EA Project No.: 15-2100

DATE OF ADDENDUM ISSUANCE: Monday, February 1, 2016

The Project Manual and Drawings dated January 15, 2016 for the above referenced project are hereby amended as follows:

PARK MIDDLE SCHOOL ADDITION

1 WELL FIELD SITE PLAN
 M202 SCALE: 1/16" = 1'-0"

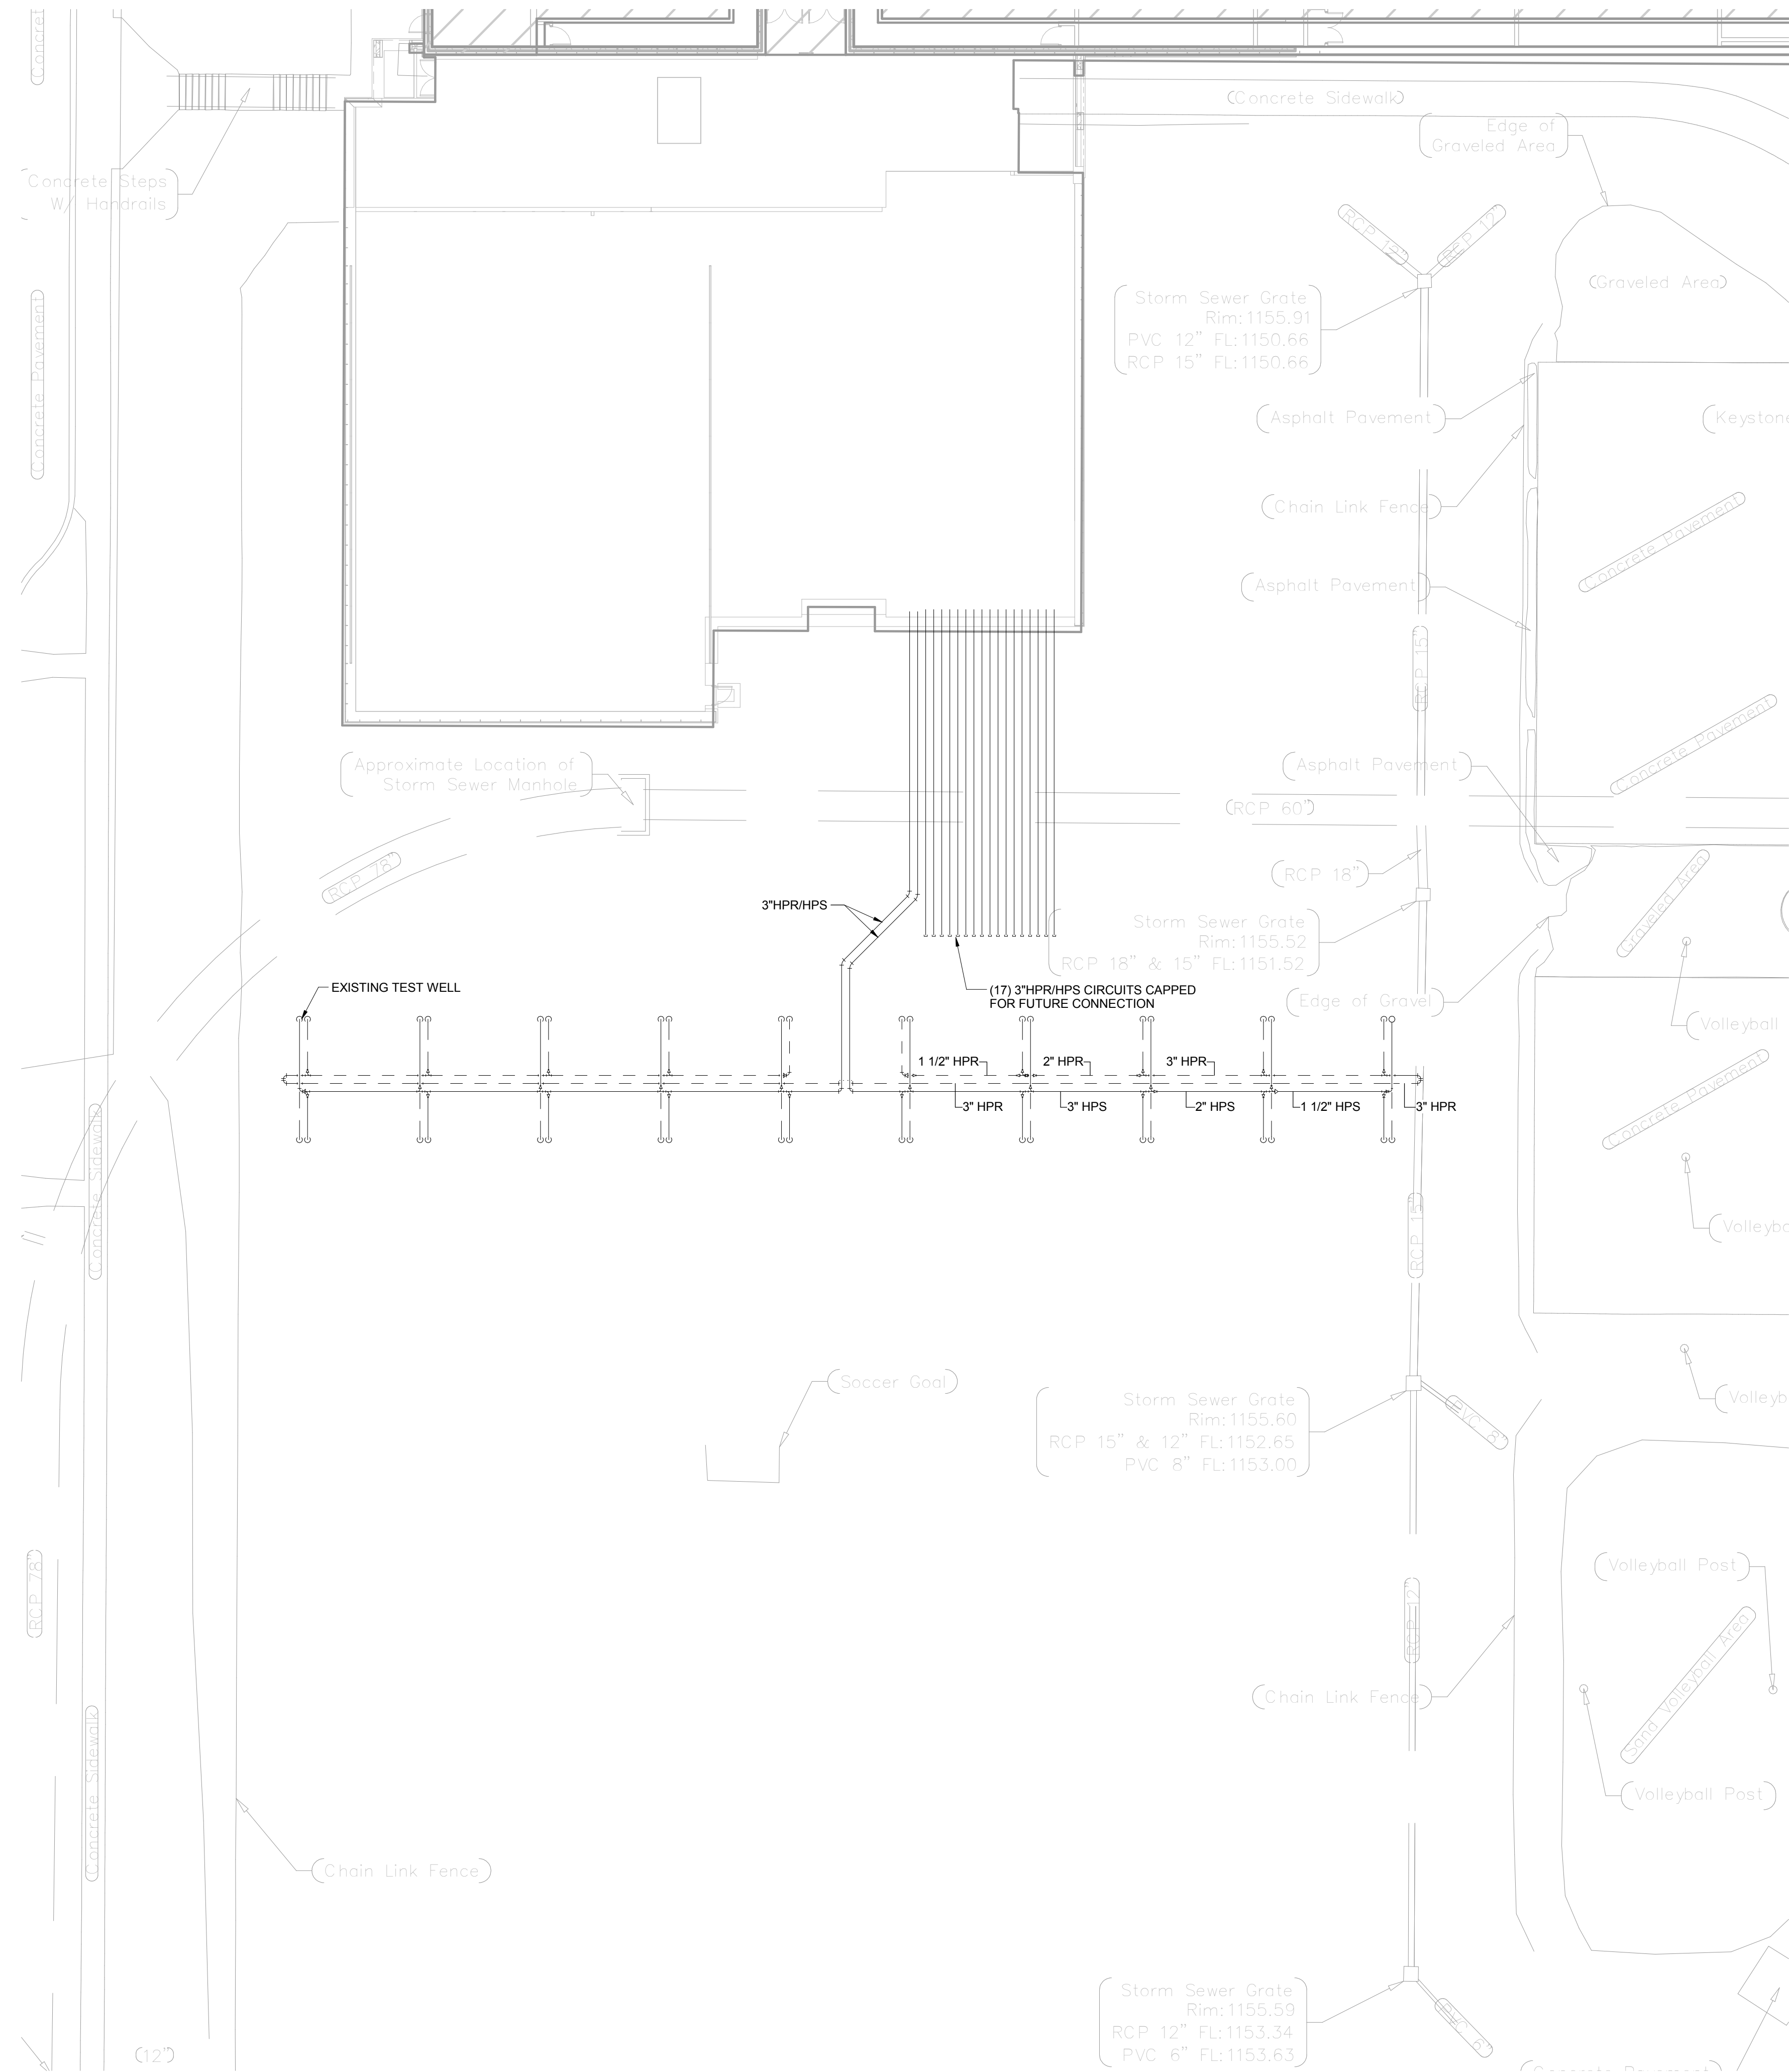
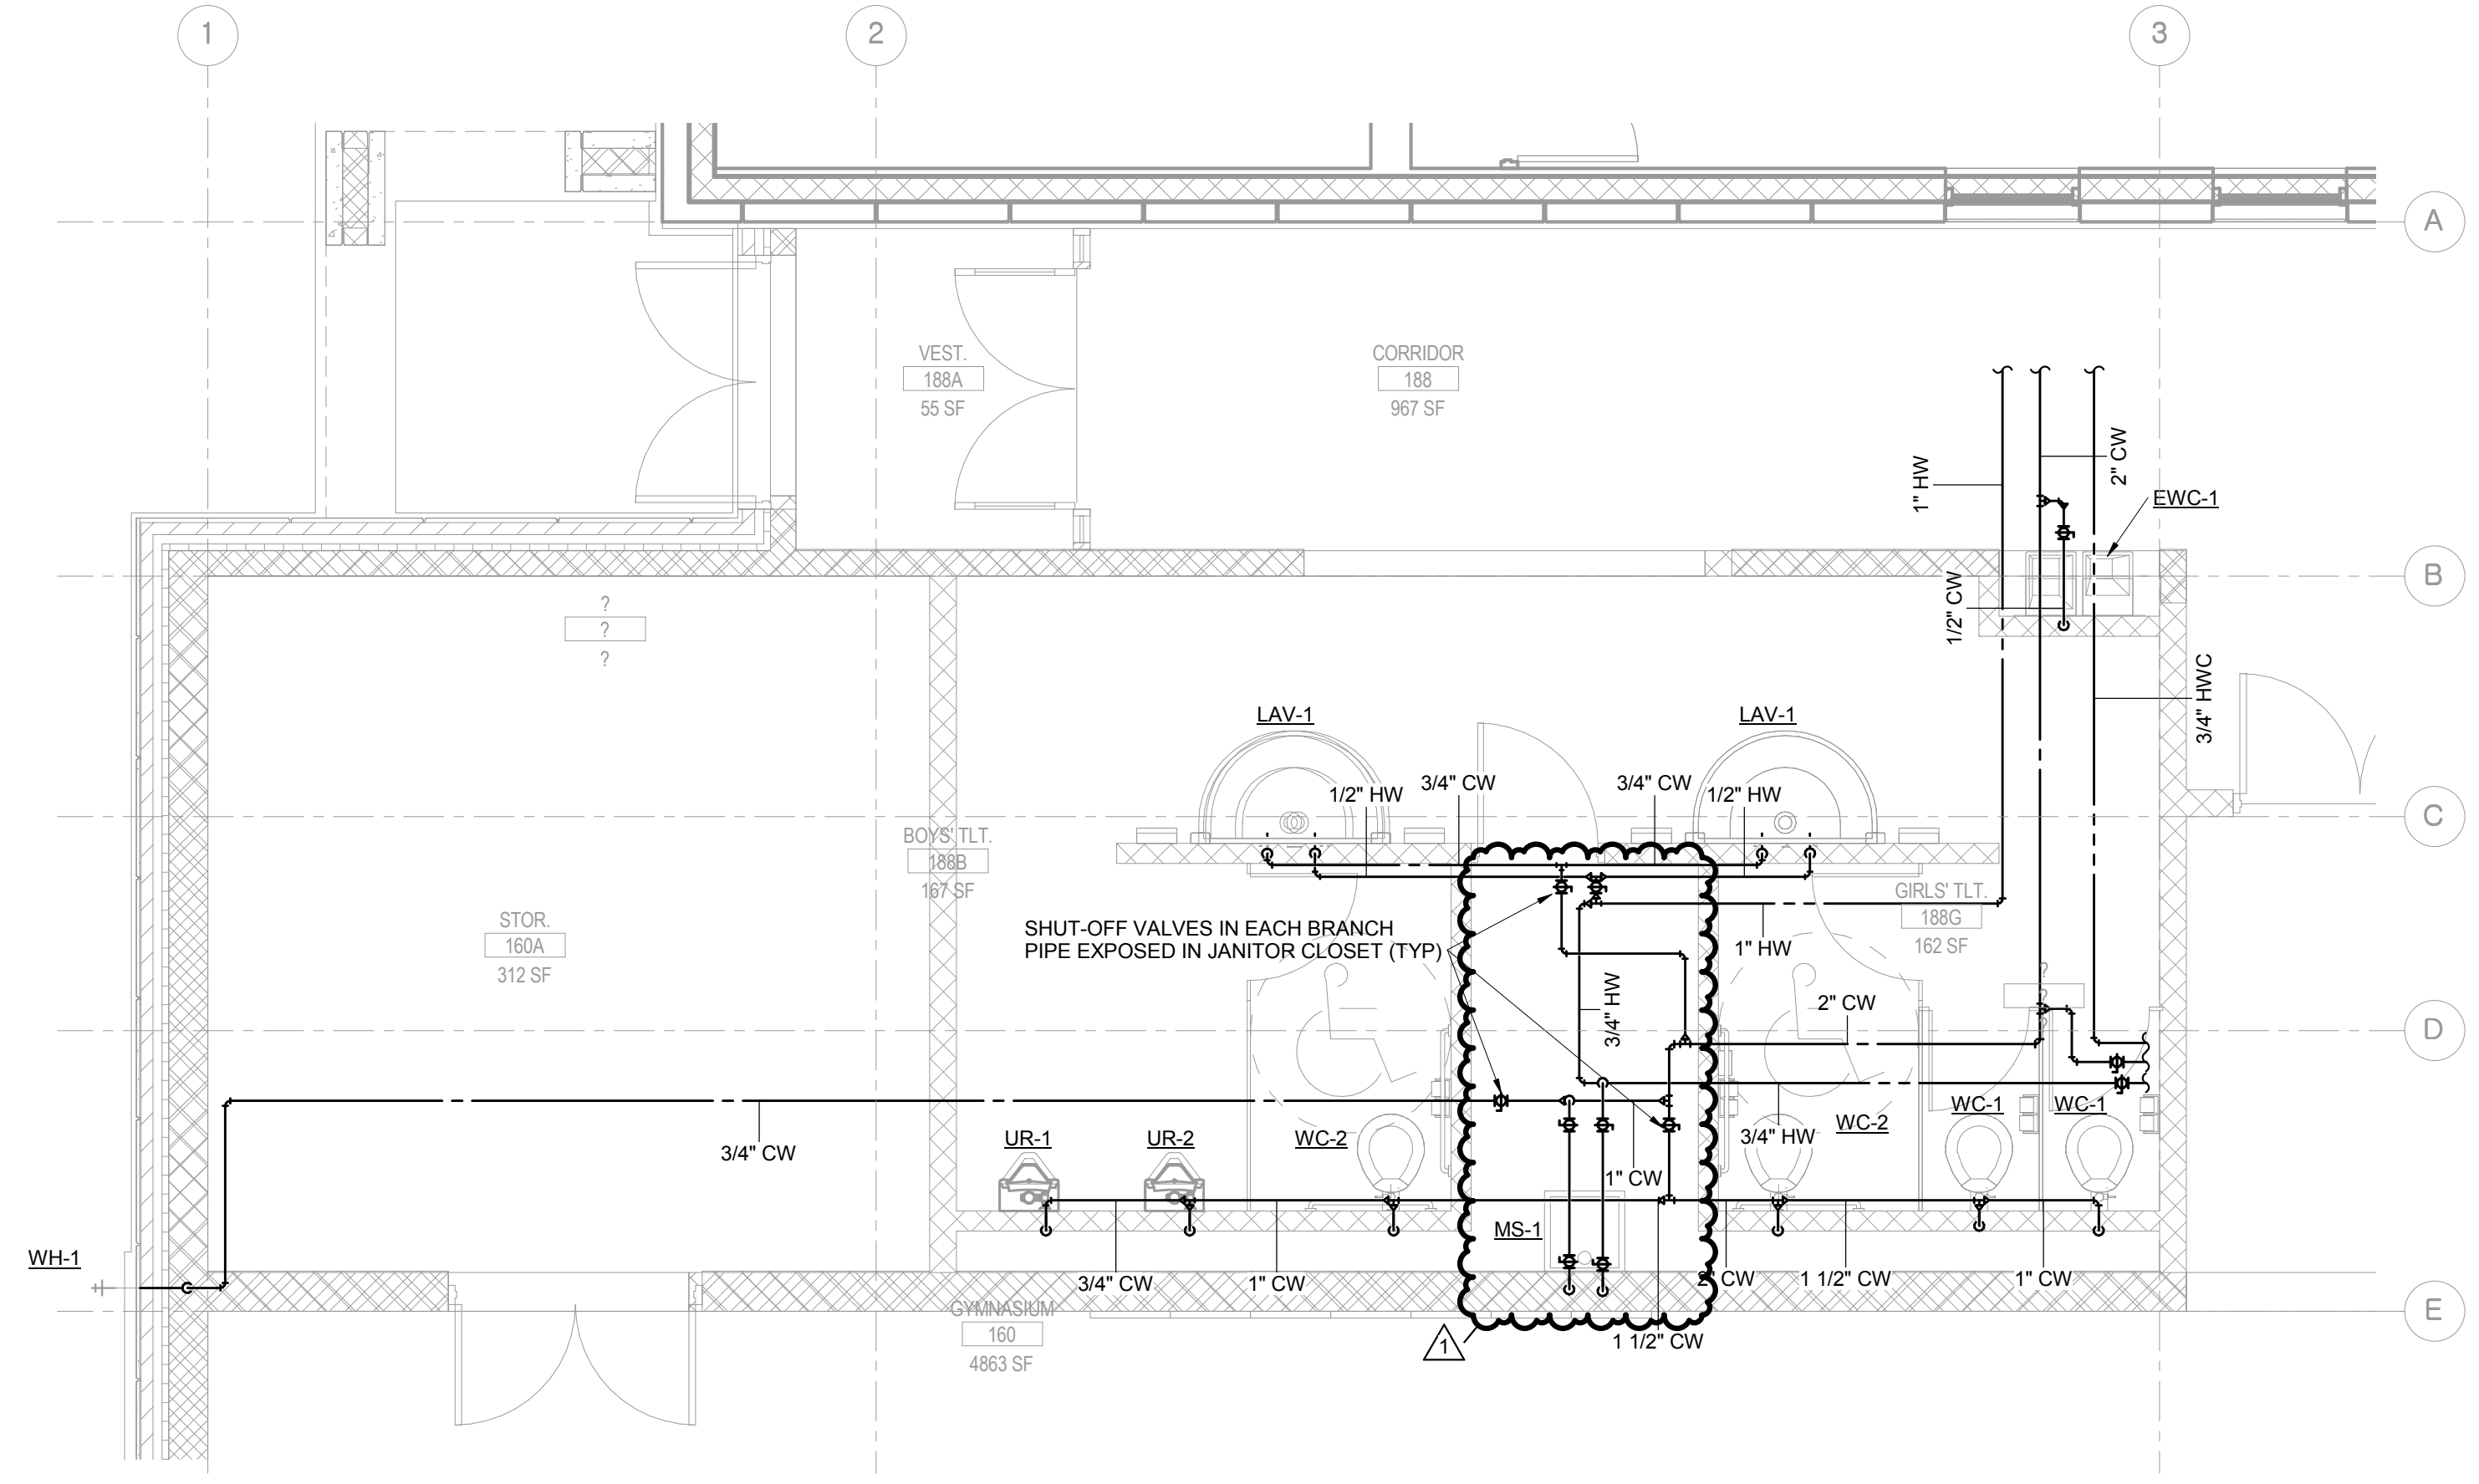
- A. Replace sheet in its entirety with attached Sheet 'M202 – Well Field Site Plan'; plan has been updated to coordinate with site plan (see 'Attachment C').

2 ENLARGED PLUMBING PLAN
SCALE: 1/4" = 1'-0"

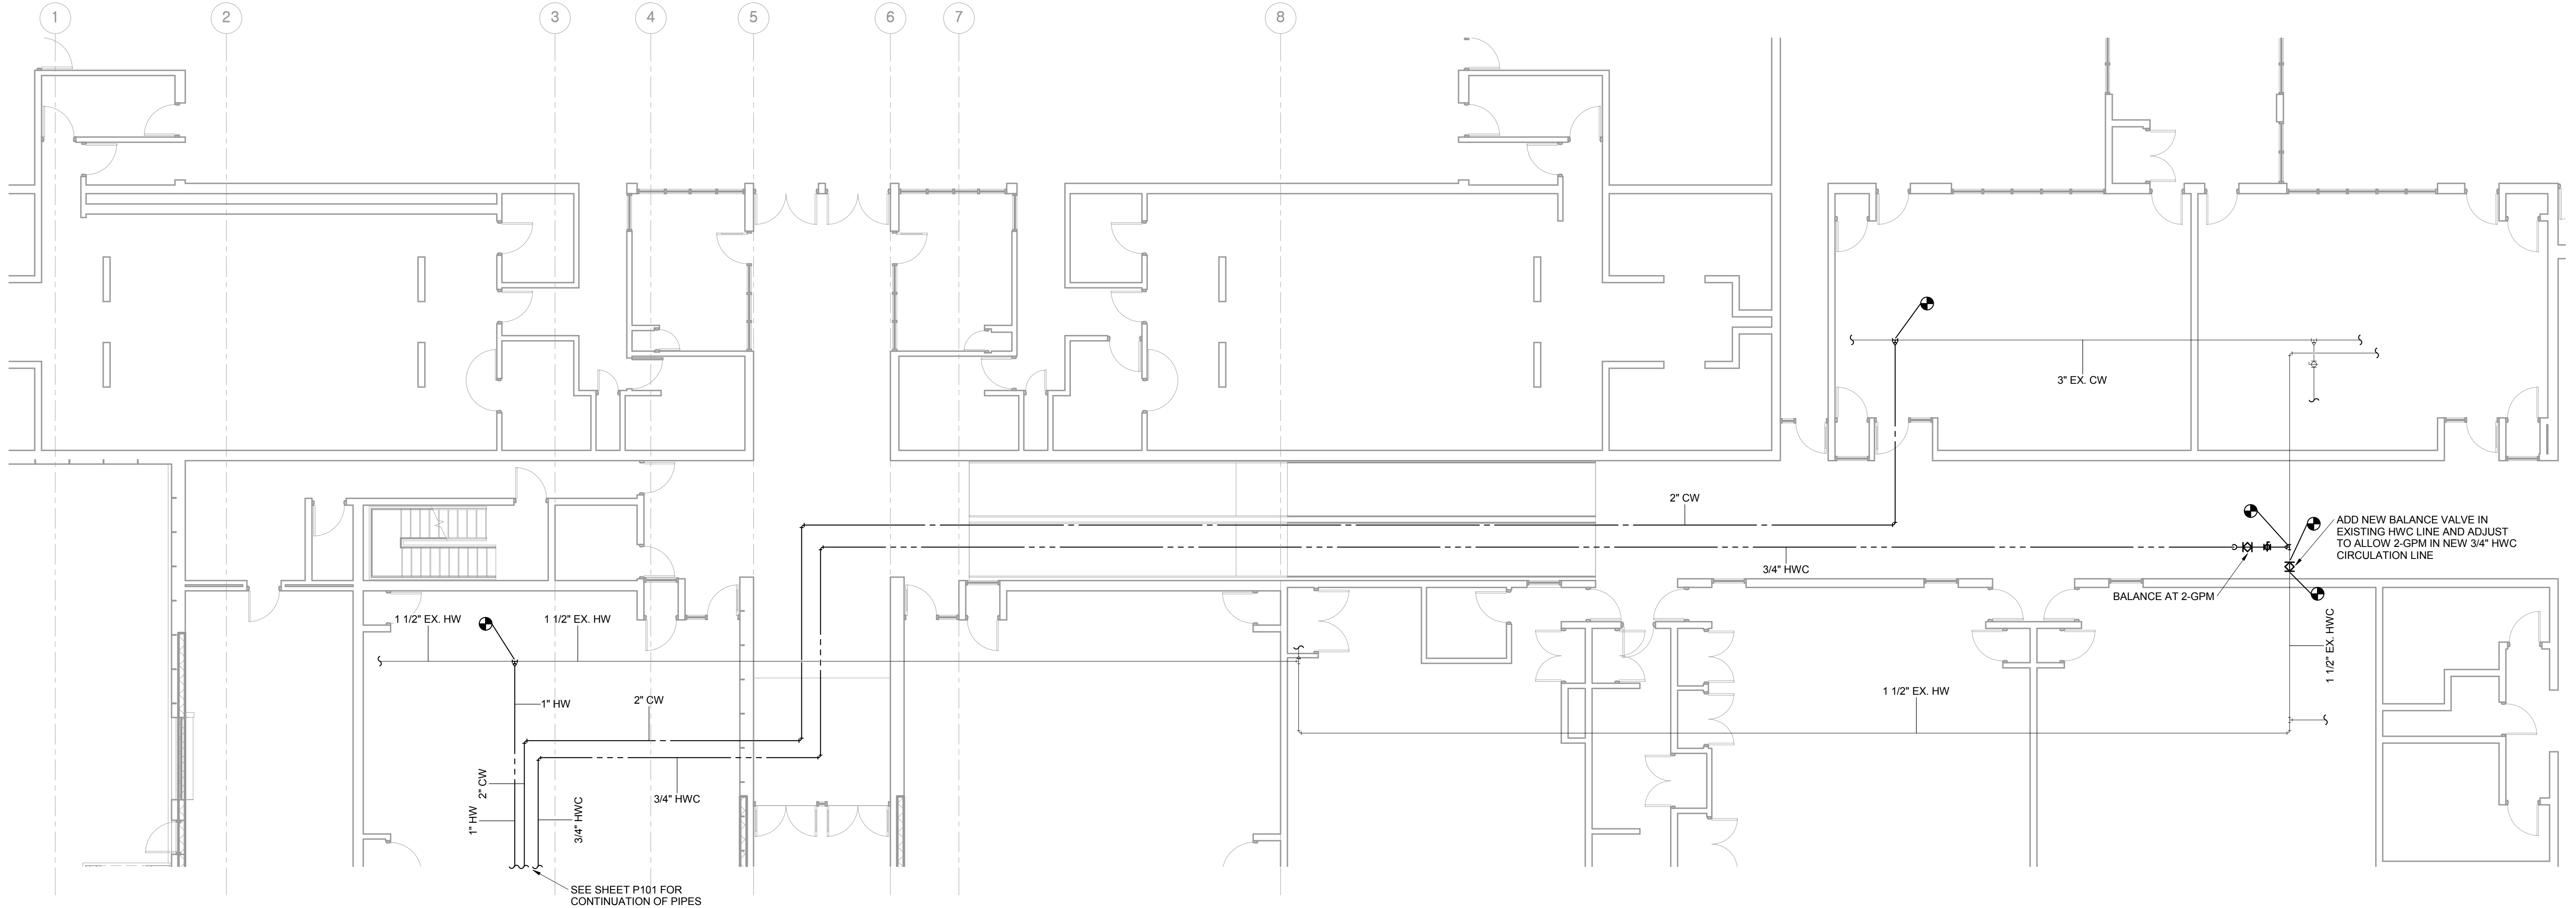
- A. Replace sheet in its entirety with attached Sheet ' P201 – Enlarged Plumbing Plan'; corrected location of mop sink and pipe routing (see 'Attachment C').
